TRACY'S SUBDIVISION (MINOR REPLAT)

Applicant's Request: The applicant intends to replat a former church property for redevelopment into six (6) single-family homes. The property is located in the south Lake Como neighborhood.

Staff Recommendation: Approval of the Minor Plat, subject to conditions in this staff report.

Updated: April 2, 2016

PROPOSED SUBDIVISION PLAN (REVISED 4/1/2016)

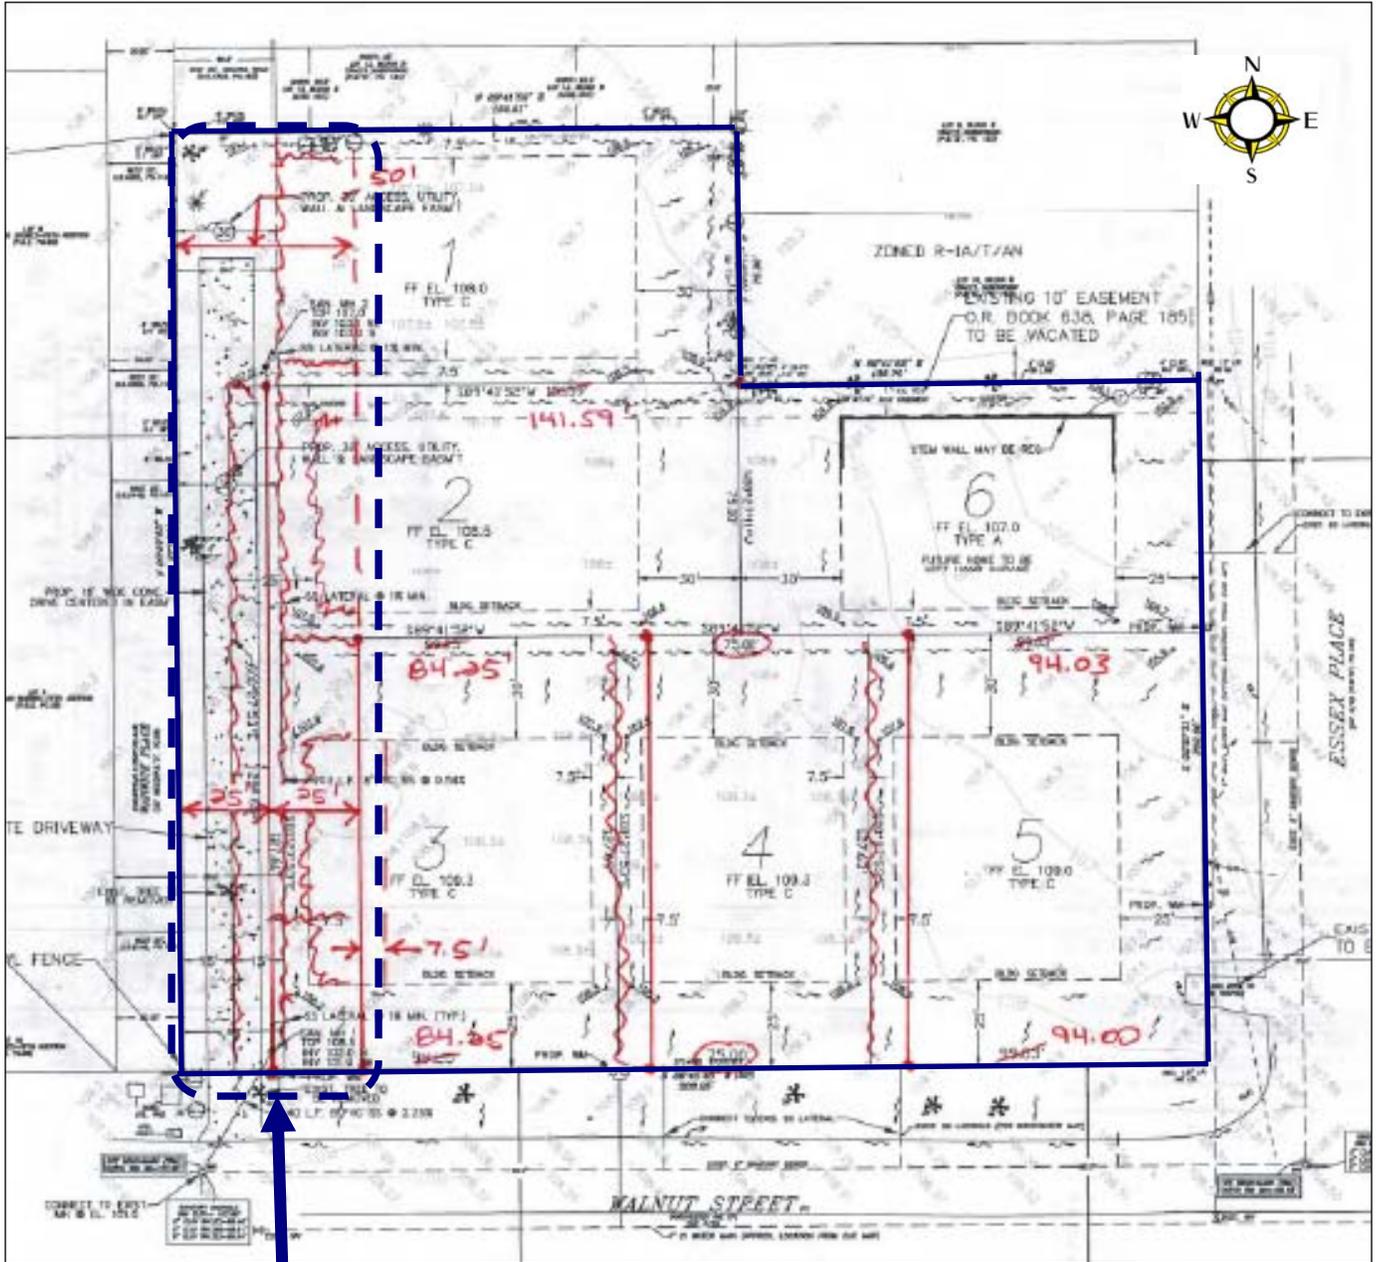
THIS EASEMENT WIDENED TO 50 FT. WIDTH TO ALLOW LOTS 1 & 2 TO HAVE 25 FT. BUILDING SITE FRONTAGE ON WALNUT ST., AS REQUIRED BY R-1A/T/AN ZONING. EASEMENT TO INCLUDE MIN. 16-FT. WIDE SHARED DRIVEWAY AND AMPLE ROOM FOR UTILITY LINES, POSSIBLE SIDEWALK AND LANDSCAPING. LINES FOR LOTS 3, 4 & 5 HAVE ALSO BEEN SHIFTED TO ACCOMMODATE THE WIDER 50 FT. EASEMENT. ALL PROPOSED LOTS MEET CODE.
